**Landmark Commission/Architectural Board of Review Agenda  
Via Video and Audio Conference Due to  
COVID-19 Public Health Emergency  
Wednesday, August 26, 2020, 7 PM  
Zoom webinar ID: 953 5215 6480  
Password: 33553400**

## Memorandum

Re: **Certificate of Appropriateness: 3756 Lee Road (Lee-Scottsdale Building)—Wireless Antennae.** Ronald Gainar, representing T-Mobile.

**ELEVATION**

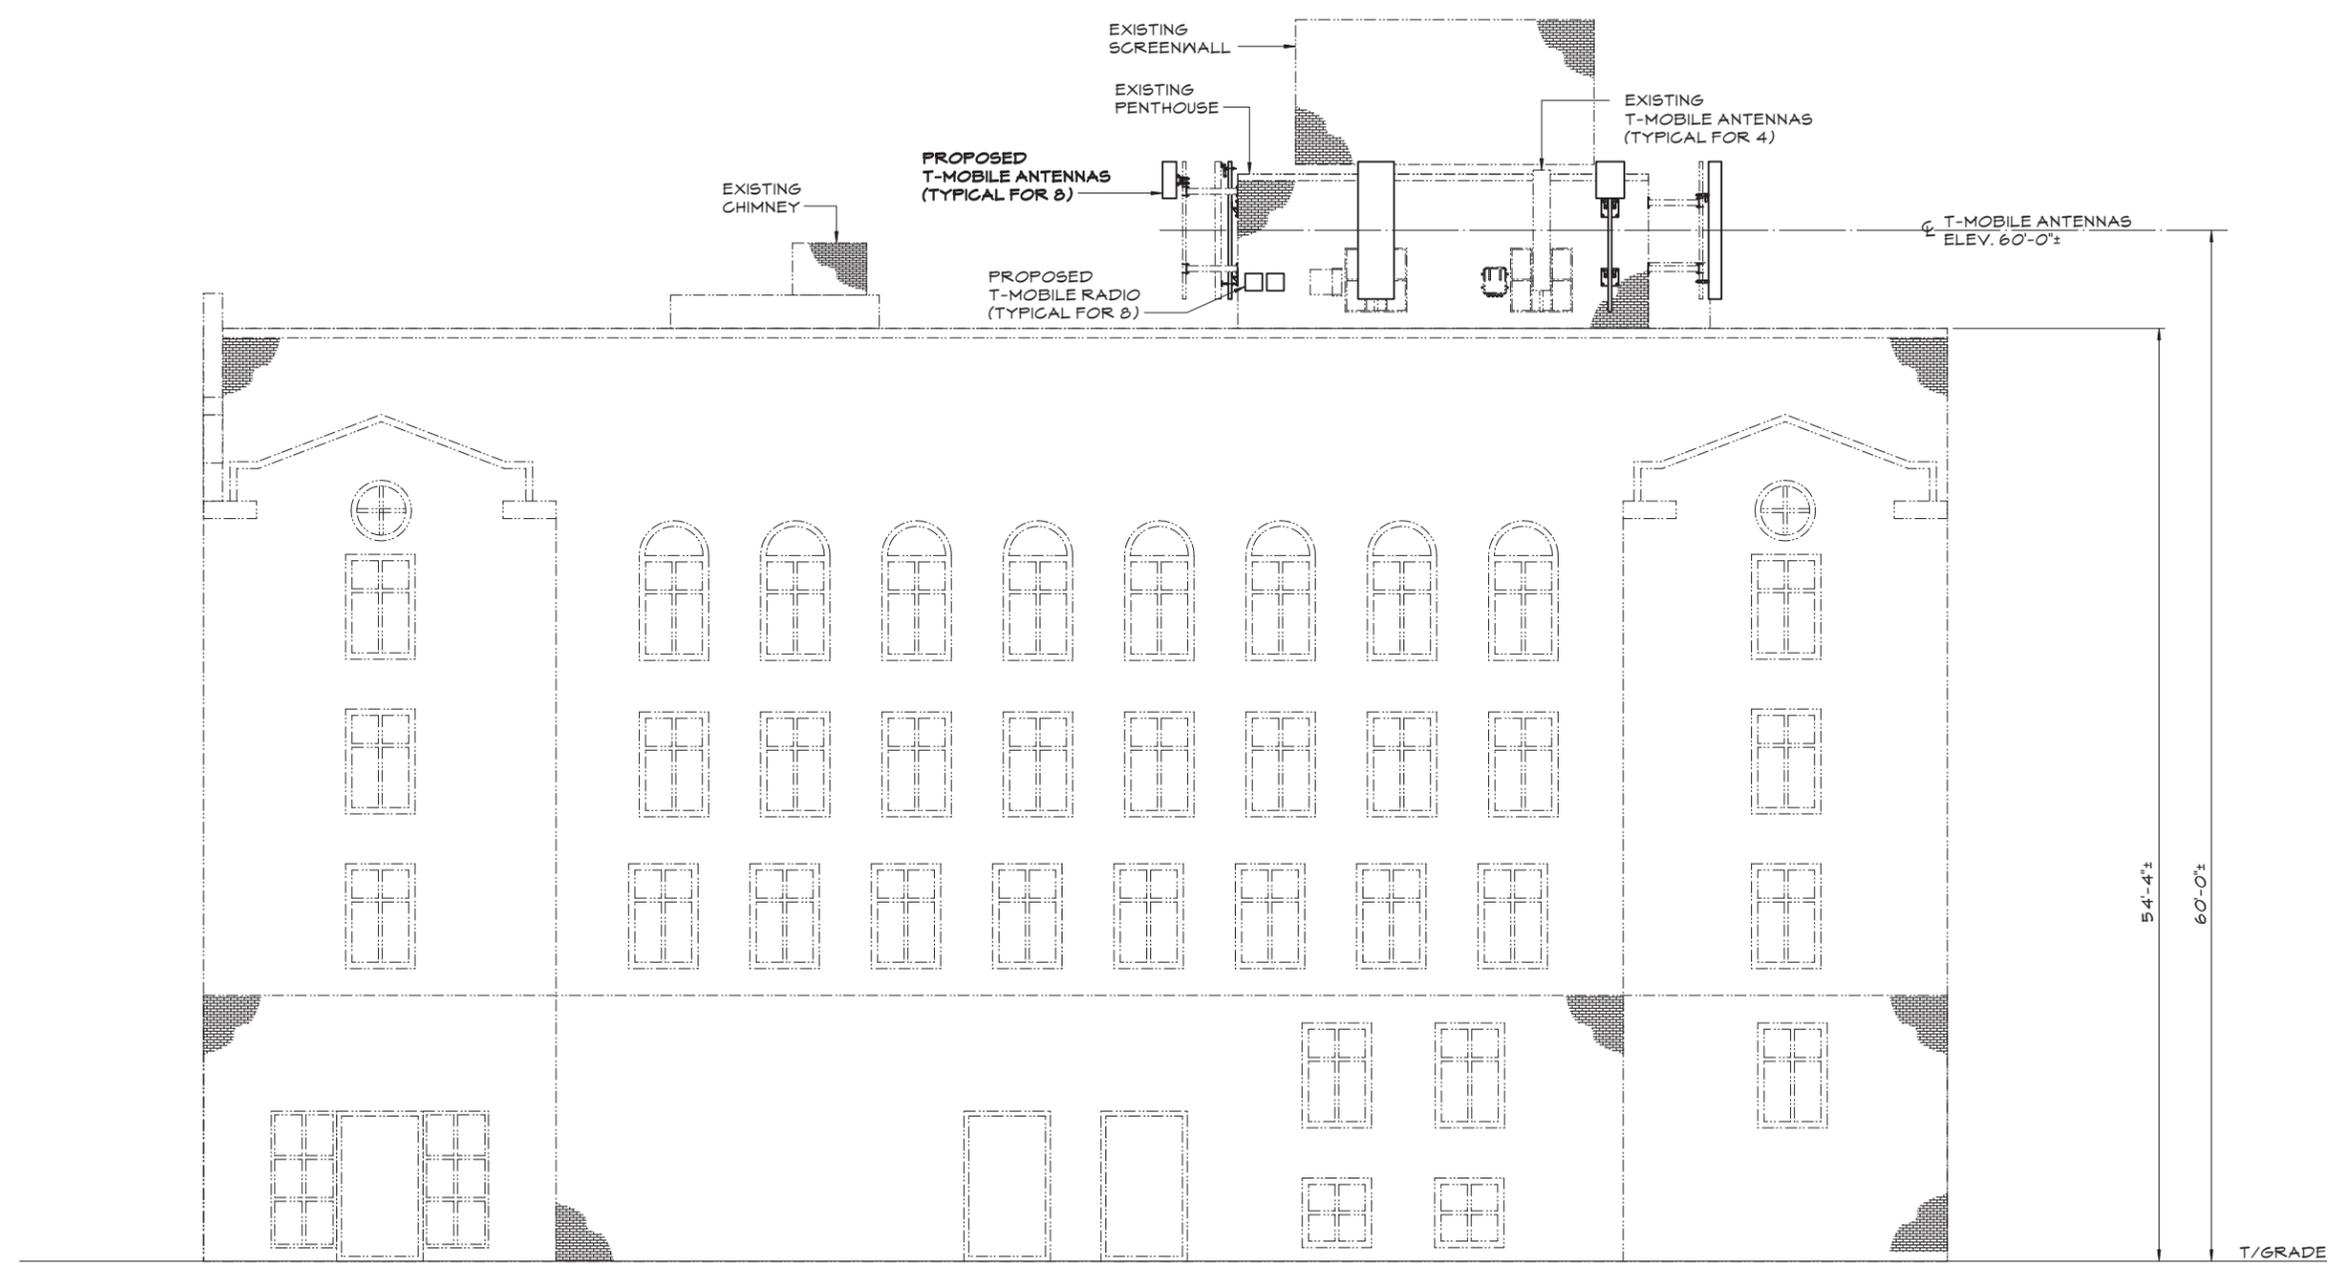
Staff recommends approval of the Certificate of Appropriateness for additional antennas with the condition that cabling remain near the bottom of the existing penthouse. According to the submitted photo simulations, the increased number of antennas will be more noticeable from north and south views, but the change is not drastic and will not obstruct the historic front façade view of the building.

1. ANTENNA TO BE MOUNTED TO MIN. 2 7/8" SCH. 40 PIPE MAST. CONTRACTOR TO VERIFY PIPE MAST SIZE, LENGTH AND SCH. UPGRADE IF REQUIRED.
2. ANTENNA AND RRU CABLEING TO BE CONNECTED PER RF DATA SHEET, PROVIDED BY RF ENGINEER.
3. ALL NEW ANTENNAS, MOUNTS, CABLEING, ETC. TO BE PAINTED TO MATCH THE COLOR OF THE PENTHOUSE.
